CORNERSTONE PLANNED UNIT DEVELOPMENT

CORNERSTONE P.U.D.

SCALE			HURST & ASSOCIATES, INC. CONSULTING ENGINEERS 3055 4th Street, S.E. Boulder, Colorado 80508 (303) 440-9805
DESIGN			
DRAWN	R.J.L.		
CHECKED			
APPROVED		JOB NO. 1009-52 DATE 5/90 SHEET 1 OF 2

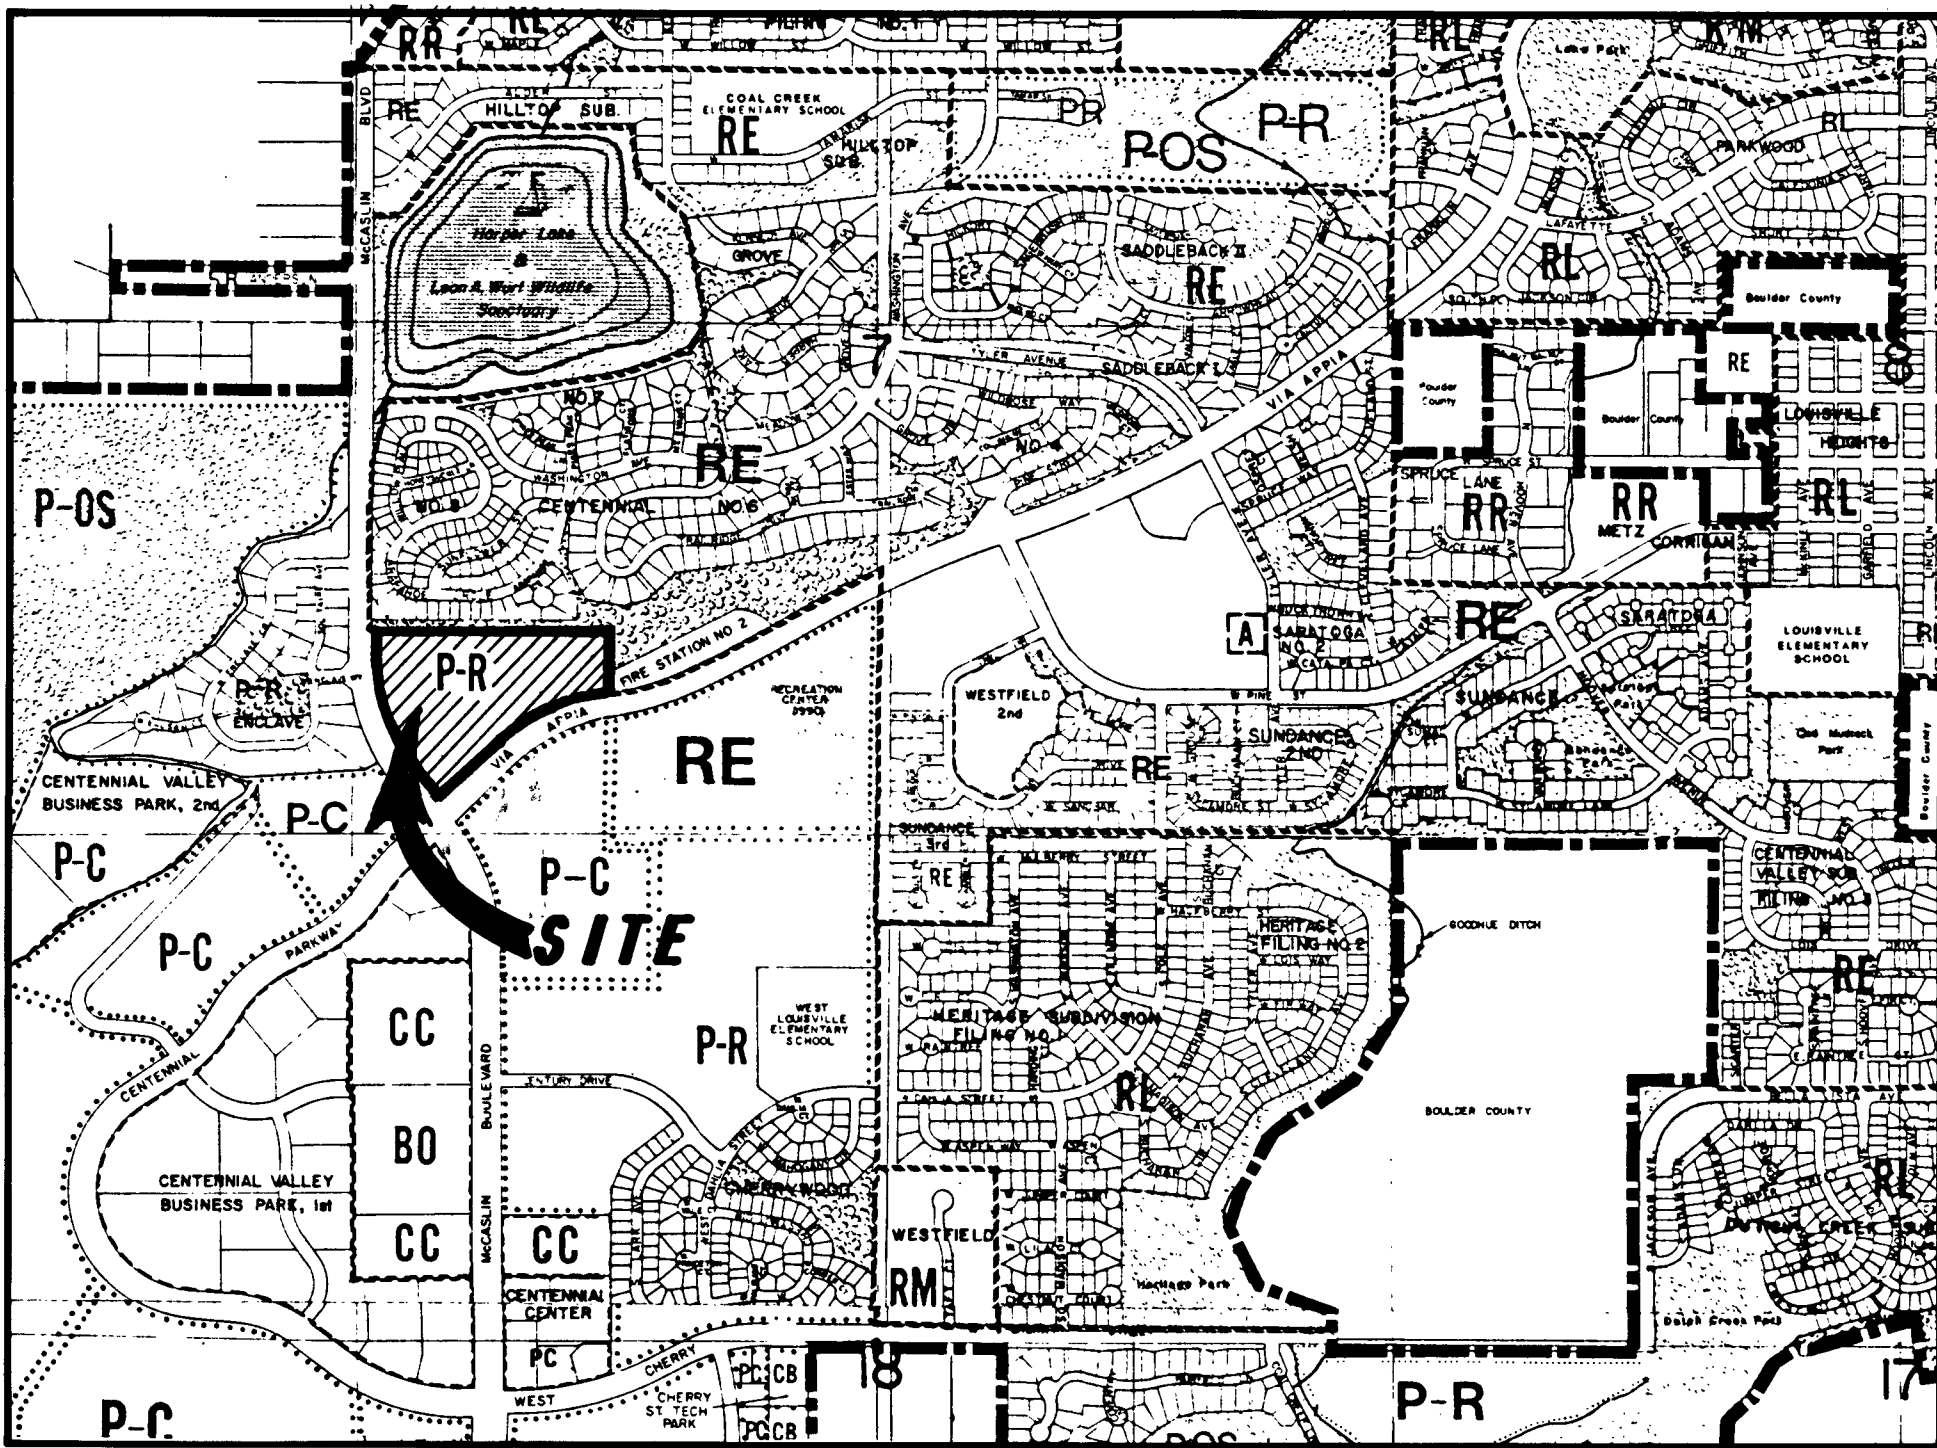
~~SOLID FENCE DESIGN CRITERIA - SOLID INTERIOR FENCES SHALL BE A MAXIMUM OF 72" HIGH WITH 1 X 6 R.C. VERTICAL BOARDS ON 4"X4" POSTS @ 48" O.C. WITH 1/4" SPACING BETWEEN BOARDS, STAINED-CABOT SEMISOLID DUNE GREY OR EQUAL W/FINISHED SIDE OUT.~~

~~OPEN STYLE FENCE DESIGN CRITERIA - 42" HIGH SPLIT RAIL (UNLESS OTHERWISE NOTED ON THE P.U.D.)~~

~~EXTERIOR FENCES ALONG MCCASLIN BOULEVARD AND VIA APPIA TO BE INSTALLED BY DEVELOPER.~~

~~WHERE DEVELOPER INSTALLS FENCING AS SHOWN ON THE P.U.D. PLAN, NO ADDITIONAL PARALLEL FENCING WILL BE ALLOWED WITHIN THE BUILDING SETBACK.~~

~~3/25/92. Fence support post spacing amended to permit 5' spacing. John Franklin DCD.~~
